<b>North – South Commuter Railway (NSCR) Project (Malolos – Tutuban)</b> <b>Package CP01: Elevated Structures, 7 Stations and Depot</b>			
<b>ITEM NO.</b>	<b>REFERENCE CLAUSE/ SECTION</b>	<b>CLARIFICATION REQUEST</b>	<b>RESPONSE</b>
<i>Volume I, Part 1 – Bidding Procedures</i>			
1		<p>We have noted the following in the Key Project Information: STEP Requirement : Total costs of goods and services procured from Japan as a percentage of the accepted contract amount, including provisional sums, shall not be less than: - CP01 - 16% - CP02 - 13%</p> <p>May we know if you have set any definition of "Japan company" as supplier? Will the above requirement be applied also on the insurance procurement?</p> <p>Please see below to further illustrate our inquiry: <b>Project Name : CP01</b> If a bidder procure insurance from a 49% Japanese-owned insurance company, how much % of the <b>CP01 - 16%</b> requirement has already been complied? Would it be: a) 49% of the insurance cost since the insurance company is just 49% Japanese owned b) 100% of the insurance cost since the insurance company which is 49% Japanese owned has already cleared the requirement as a "Japan company" supplier</p>	<p>For th

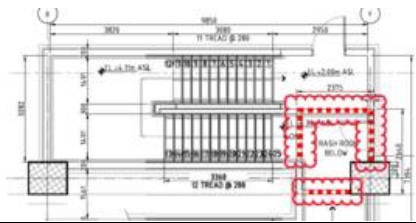
104	Book 4 of 11,	At Concourse Level Breastfeeding Room, the Existence of	Yes, the Bidder’s assumption is acceptable.

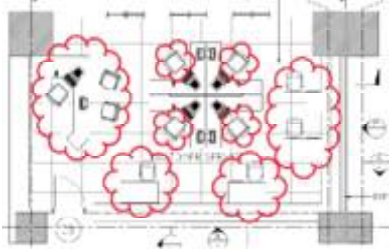
151	Book 6 of 11, Pages CP01-B6-300, CP01-B6-303 and CP01-B6-337	At Concourse Level Costumer Service Room, floor finish differs as follows, CP01-B6-300 MARILAO STATION - ARCHITECTURAL CONCOURSE AND PLATFORM LEVEL FLOOR PATTERN LAYOUT PLAN AND DETAILS ... 600 x 600mm thk. Vitrified Ceramic Floor Tile  CP01-B6-303 MARILAO STATION ARCHITECTURAL - SCHEDULE OF FINISHES SHEET 1 ... 150mm High Raised Access Floor System with 600 x 600mm Panels and Anti-Static Vinyl Covering and Epoxy Coating (Dust Proofer) on under floor	Section VI, 3 Drawings, Book 6 of 11, Page CP01-B6-303 shall be followed.

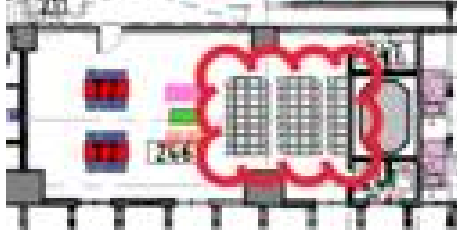
153	Book 6 of 11, Pages CP01- B6-303 and CP01-B6-328	At Steps 1 and 2, the existence of Step Blocks differs as follows, CP01-B6-303 MARILAO STATION ARCHITECTURAL - SCHEDULE OF FINISHES SHEET 1	Detail C of the Drawing in Section VI, 3 Drawings, Book 6 of 11, Page No. CP01-B6-328 is correct and shall be followed.
		<p style="padding-left: 40px;">... Existent</p> <p>CP01-B6-328 MARILAO STATION ARCHITECTURAL - STAIR DETAILS SHEET 2 (DETAIL C)</p> <p style="padding-left: 40px;">... Non-existent</p>

<b>North – South Commuter Railway (NSCR) Project (Malolos – Tutuban)</b> <b>Package CP01: Elevated Structures, 7 Stations and Depot</b>			
<b>ITEM NO.</b>	<b>REFERENCE CLAUSE/ SECTION</b>	<b>CLARIFICATION REQUEST</b>	<b>RESPONSE</b>
		May we assume the one indicated in CP01-B6-328 MARILAO STATION ARCHITECTURAL - STAIR DETAILS SHEET 2 (DETAIL C), Non-existent, to be correct?	
154	Book 6 of 11, Pages CP01-B6-303 and CP01-B6-329	At Emergency Exit 1, 2, 3 and 4, the existence of Step Blocks differs as follows, CP01-B6-303 MARILAO STATION ARCHITECTURAL - SCHEDULE OF FINISHES SHEET 1 ... Non-existent CP01-B6-329 MARILAO STATION ARCHITECTURAL - STAIR DETAILS SHEET 3 (SECTION 1) ... Existent May we assume the one indicated in CP01-B6-329 MARILAO STATION ARCHITECTURAL - STAIR DETAILS SHEET 3 (SECTION 1), Existent, to be correct?	The Drawing in Section VI, 3 Drawings, Book 6 of 11, Page No. CP01-B6-329 is correct and shall be followed.

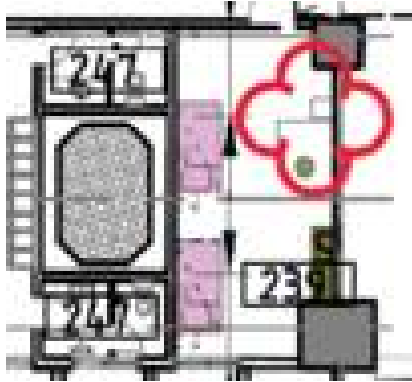
157	Book 6 of 11, Page CP01-B6-327	In CP01-B6-327 MARILAO STATION ARCHITECTURAL – RAMP DETAIL SHEET 1, Please provide the specification and detail of the Handicapped Floor Sign shown on Ramp Plan Detail.	Please follow the relevant Technical Specifications and Drawings in the Bidding Documents. Also, the shop drawings shall be submitted based on standard product for review of the Engineer as per GS 100 Clause 120.4.3.
158	Book 6 of 11, Page CP01-B6-328	At CP01-B6-328 MARILAO STATION ARCHITECTURAL - STAIR DETAILS SHEET 2, the stair width differs as follows, DETAIL B ···W=3400 ELEVATION 2A ···W=3250 May we assume the one indicated in DETAIL B, W=3400, to be correct?	W=3400 is correct. The Contractor shall submit the shop drawings for approval of the Engineer as per GS 100 Clause 120.4.3.
159	Book 6 of 11, Page CP01-B6-328	In CP01-B6-328 MARILAO STATION ARCHITECTURAL – STAIR DETAILS SHEET 2, May we assume the detail of the Rain Gutter and Grating to be the following:	Yes, the Bidder's assumption is acceptable.

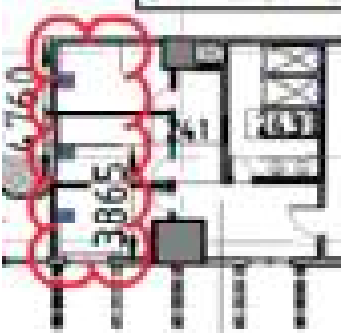
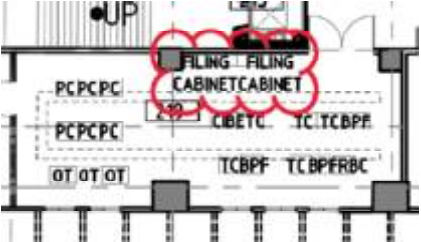
165	Book 6 of 11, Page CP01-B6-337	At CP01-B6-337 MARILAO STATION ARCHITECTURAL-CUSTOMER SERVICE ROOM DETAILS 1, may we assume the item shown below to be the following?	Yes, the Bidder's assumption is acceptable.

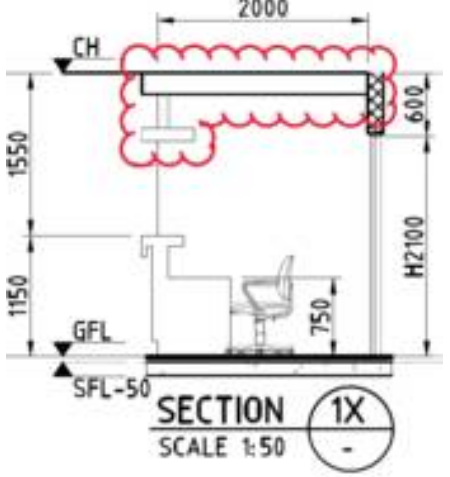
236	Book 8 of 11, Page CP01-B8-240	<p>At CP01-B8-240 VALENZUELA DEPOT-OCC BUILDING ARCHITECTURAL – SCHEDULE OF DOORS Third to Fifth Floor, Hardware Schedule for door (D2,D3,D4,D8,D10,D12,D14,D15,D22,D23) is indicated as A(for Glass Doors), since door (D2,D3,D4,D8,D10,D12,D14,D15, D22,D23) are steel door, may we read Hardware Schedule A as B(for Steel Doors) correct?</p>	<p>The hardware Schedule shall be marked as "B" instead of "A". Please also refer to the hardware schedule.</p>
237	Book 8 of 11, Page CP01-B8-240	<p>At CP01-B8-240 VALENZUELA DEPOT-OCC BUILDING ARCHITECTURAL – SCHEDULE OF DOORS Third to Fourth Floor, Hardware Schedule for D19 is indicated as A(for Glass Doors), since D19 is Bi-Fold Partition Wall, may we assume Hardware Schedule A is unnecessary?</p>	<p>The hardware for D19 must be inclusive with the Bi-fold partition based on the manufacturers specifications.</p>

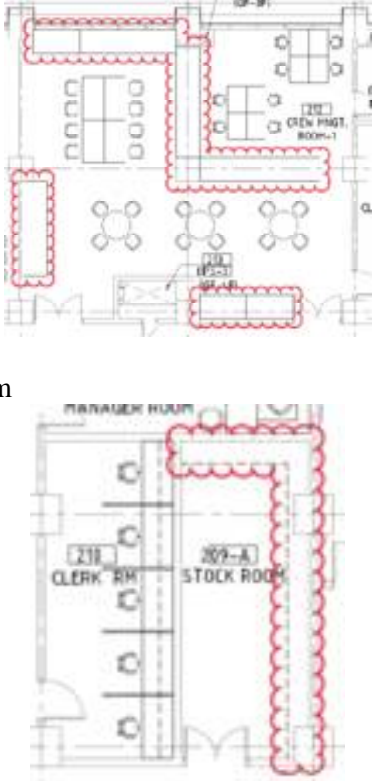
247	Book 8 of 11, Page CP01-B8-259	At CP01-B8-259 VALENZUELA DEPOT-OCC BUILDING ARCHITECTURAL-RECEPTION COUNTER AND RAILING DETAILS AT VIEWING AREA, please provide the specification and detail of clouded portion at Reception Counter.	The Contractor is advised to propose a floating type ceiling system at Reception counter.

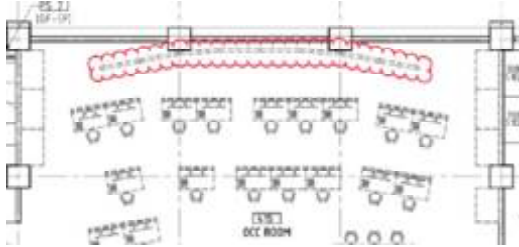
248	Book 8 of 11, Pages CP01-B8-267 to CP01-B8-270	<p>At CP01-B8-267 to 270 VALENZUELA DEPOT-OCC BUILDING ARCHITECTURAL - FURNITURE AND EQUIPMENT LAYOUT PLAN - GROUND to FOURTH FLOOR, please provide the specification and detail of the item shown below.</p> <p>GF Security Room</p>	<p>For the GF Security Room, please refer to Security Enlarge plan in Section VI, 3 Drawings, Book 8 of 11, Page CP01-B8-257. The clouded items are cabinets.</p> <p>For the GF canteen, please disregard the clouded item.</p> <p>For the Crew Management Room 1 &amp; 2F Stockroom, the clouded items are bookshelves. Please refer to the furniture list in Book 8 of 11, Page CP01-B8-273 for details.</p> <p>For the 3F Pantry, the clouded item is a cabinet.</p> <p>4F OCC room, the clouded item are monitors (by others).</p>
